## REMARKS

This is intended as a full and complete response to the Office Action dated July 20, 2005, having a shortened statutory period for response set to expire on October 20, 2005. Please reconsider the claims pending in the application for reasons discussed below.

**IN THE DRAWINGS:**

FIG. 1

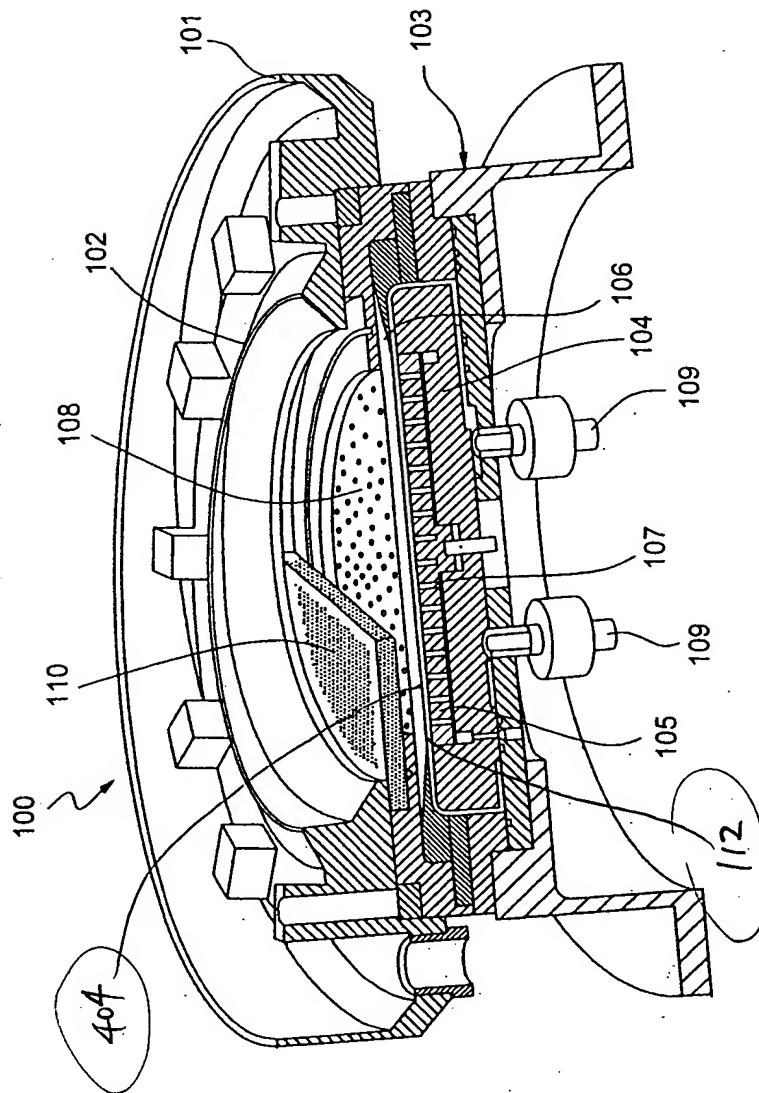
The drawings stand objected by the Examiner because element 112 is missing in the Figures. Applicants have amended Figures 1 and 5 to correct informalities and indicate the location of the membrane 112 as supported by the Specification at least in paragraphs 22-23 without introducing new matter. Withdrawal of this objection is respectfully requested.

In Figure 1, previously omitted reference number 404 and 112 have been added.

FIG. 4

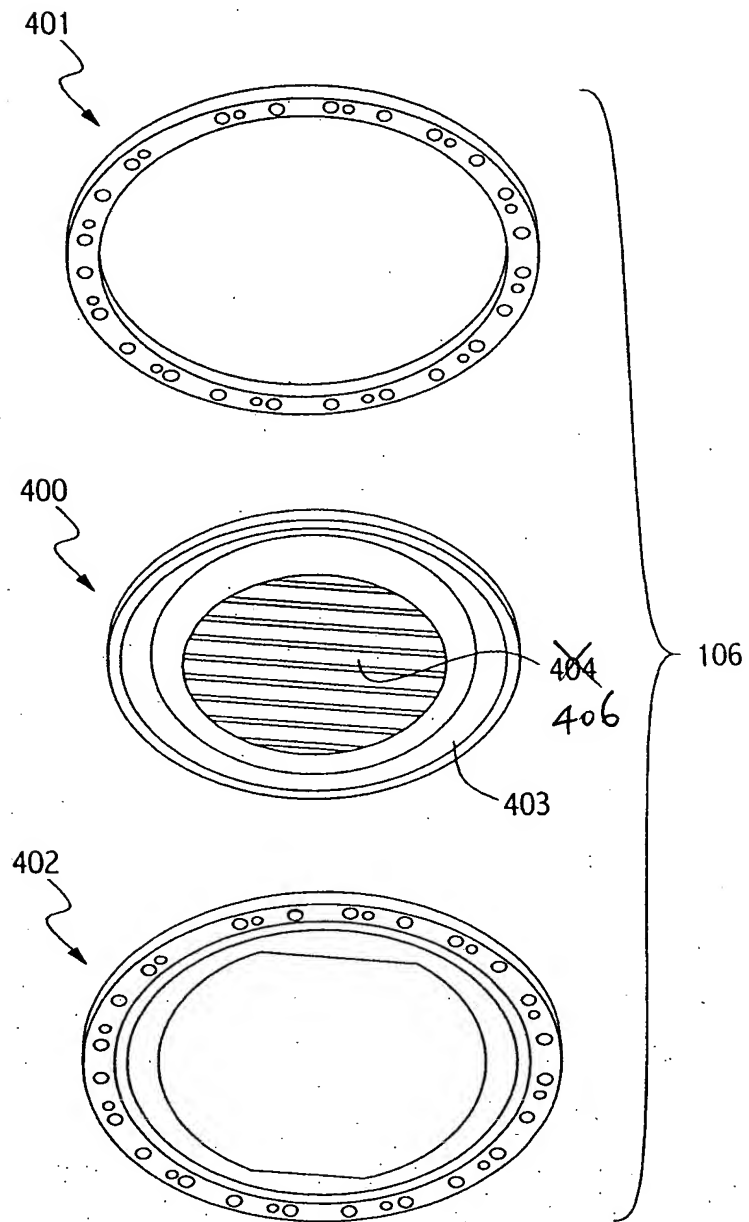
In Figure 4, reference number 404 has been renumbered to 406.

FIG. 5

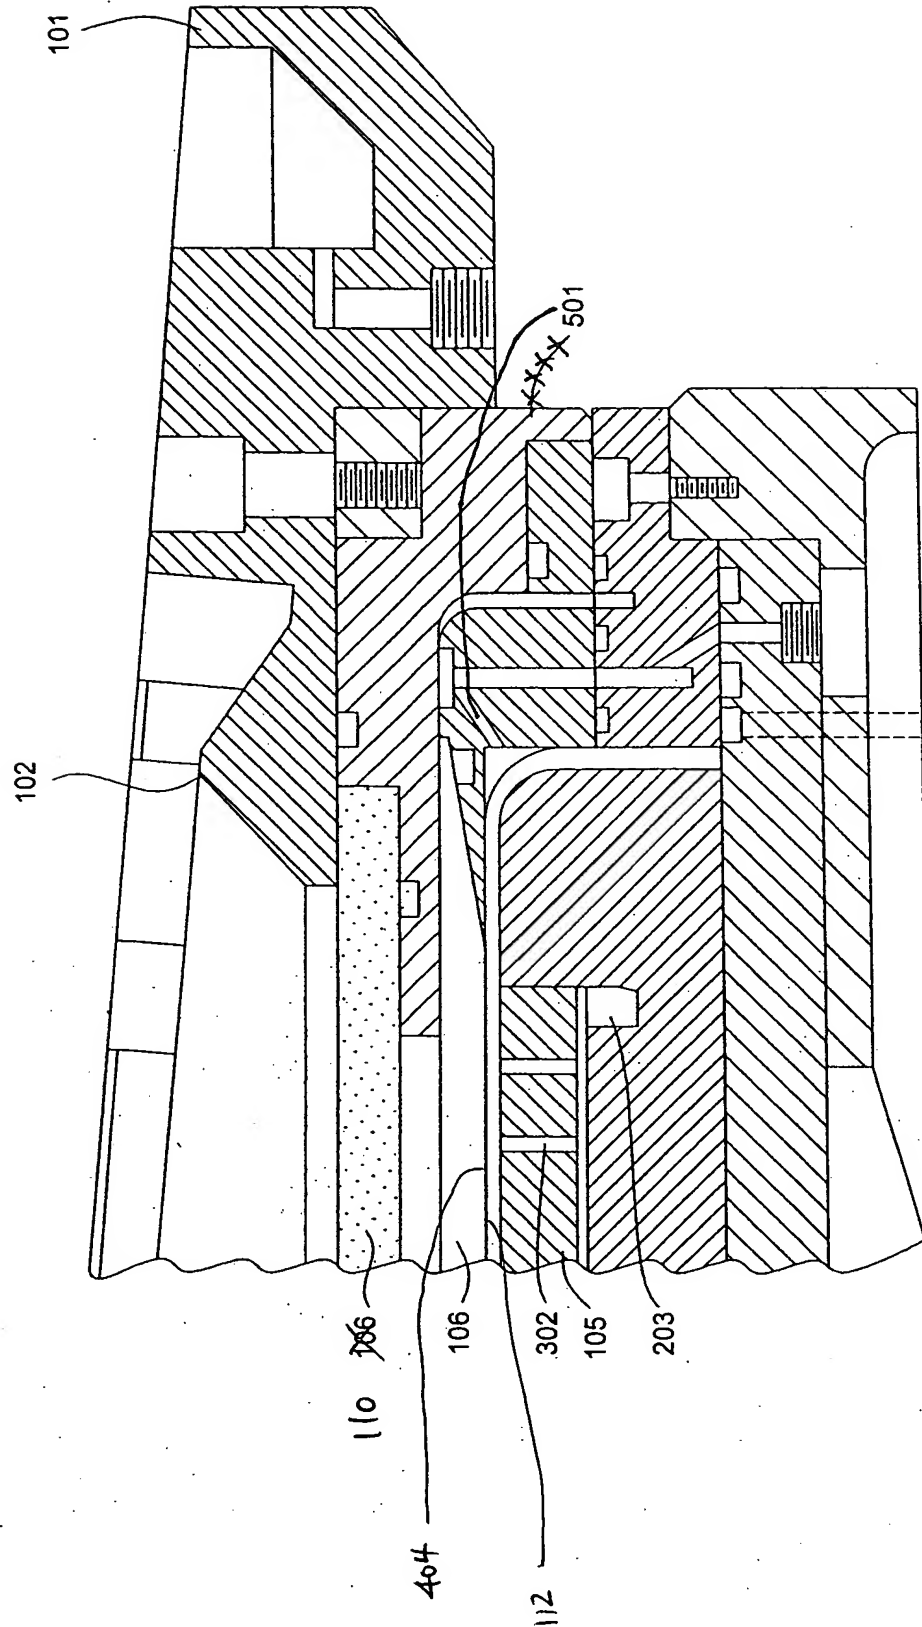
In Figure 5, previously omitted reference number 404 and 112 have been added, the lead line for reference number 501 has been corrected, and one of the duplicated reference number 106 has been changed to 110.
